THE ROVER COMPANY LIMITED

LAND-ROVER SERVICE NEWS LETTER

No. 11

June 1961

Fig. 1—Early type, pendant ball joint.

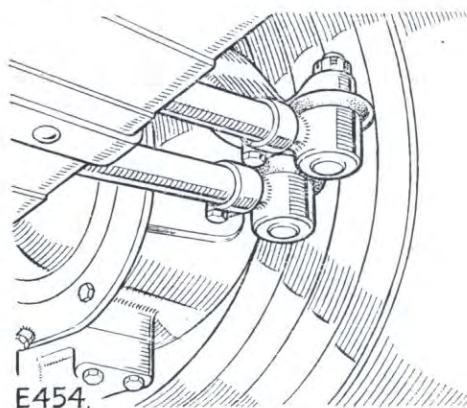
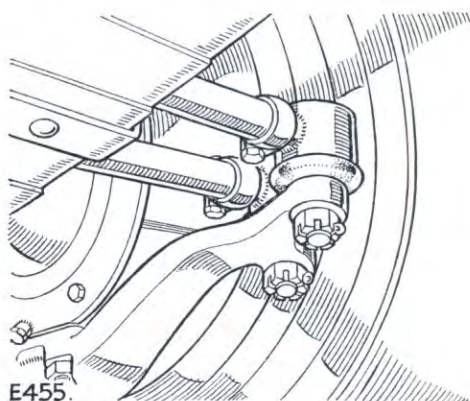
Introduction of steering ball joints fitted in the non-pendant position, that is with the ball joint above steering lever.

Early type: steering levers fitted to top of swivel housings and ball joints below levers.

Late type: steering levers fitted to bottom of swivel housings and ball joints above levers.

Swivel pin and steering levers not interchangeable as individual items, they can, however, be fitted in pairs provided either the swivel pin housing complete is changed for the latest type, or studs are fitted in the bottom position of the existing swivel pin housing. Studs required are 6 off 508152, 2 off 508153. It is most important that the latest type steering levers are not fitted to an early type housing in the lower position with the existing bolts; the studs detailed above including the special fitting studs 508153 must be fitted. This prevents any tendency for movement between lever and housing which could give rise to premature breakage of the bolts with the possibility of serious damage.

Steering track rod, not interchangeable, overall length altered as follows:

Pendant type ball joint $46\frac{1}{4}$ in. (123 cm)

Non-pendant type ball joint $45\frac{5}{8}$ in. (116 cm)

Pendant type ball joint $43\frac{3}{4}$ in. (111 cm)

Non-pendant type ball joint $43\frac{1}{8}$ in. (109 cm)
